**Third Party Review Meeting
and
International Review Group**

**Summary of Independent Findings of the 2nd Review
June 3rd – 5th 2014**

**Evaluation of Faults Near the
Tsuruga Nuclear Power Plant**

5th June 2014

Point at issue 1 - Age of the D-1 trench's geological strata (lower part of layer⑤)

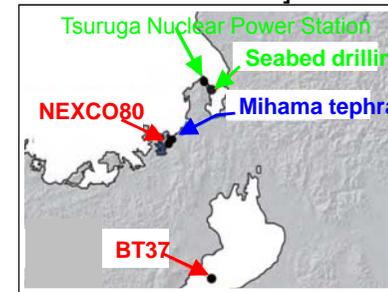
◀ Hornblende only would be insufficient.

◀ The possibility has merely been suggested, and not proven in terms of stratigraphic sequence.

Tephra in the lower part of layer⑤ = Mihama Tephra

The tephra age of the tephra in the lower part of layer⑤ is correlated with BT 37, and is therefore about 127,000 years ago.

Mahalanobis distance between tephra in the lower part of the layer⑤ and other tephra

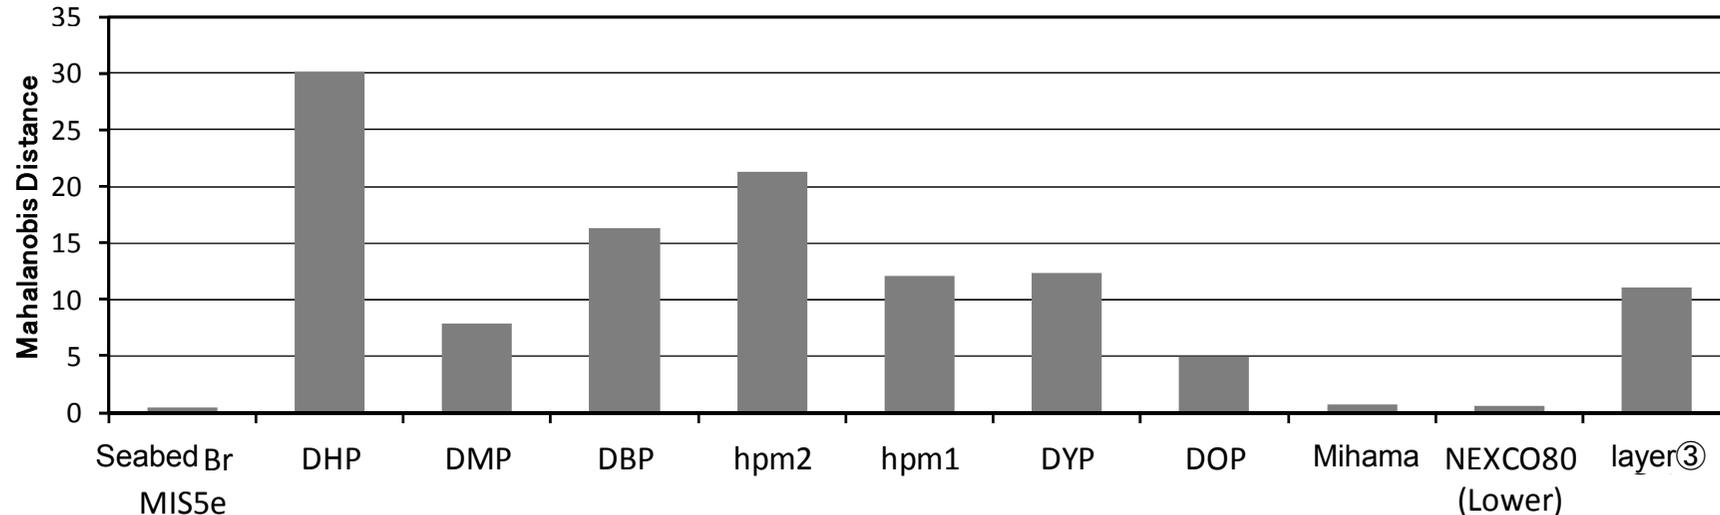
In the correlation of the results of analysis on the main ingredient composition of hornblendes, provide explanations, citing evidence, on the criteria based on which some tephra was found to resemble the tephra in the lower part of layer⑤ and some was found to be different.

- Tephra was identified by focusing also on similarities in main ingredient composition.
 - In order to determine similarities in the main ingredient composition in a more objective, quantitative fashion, we implemented DFA (Discriminant Function Analysis).
 - As a result, it was judged that "the tephra in the lower part of layer⑤ is similar to Mihama tephra and NEXCO80 (lower)".
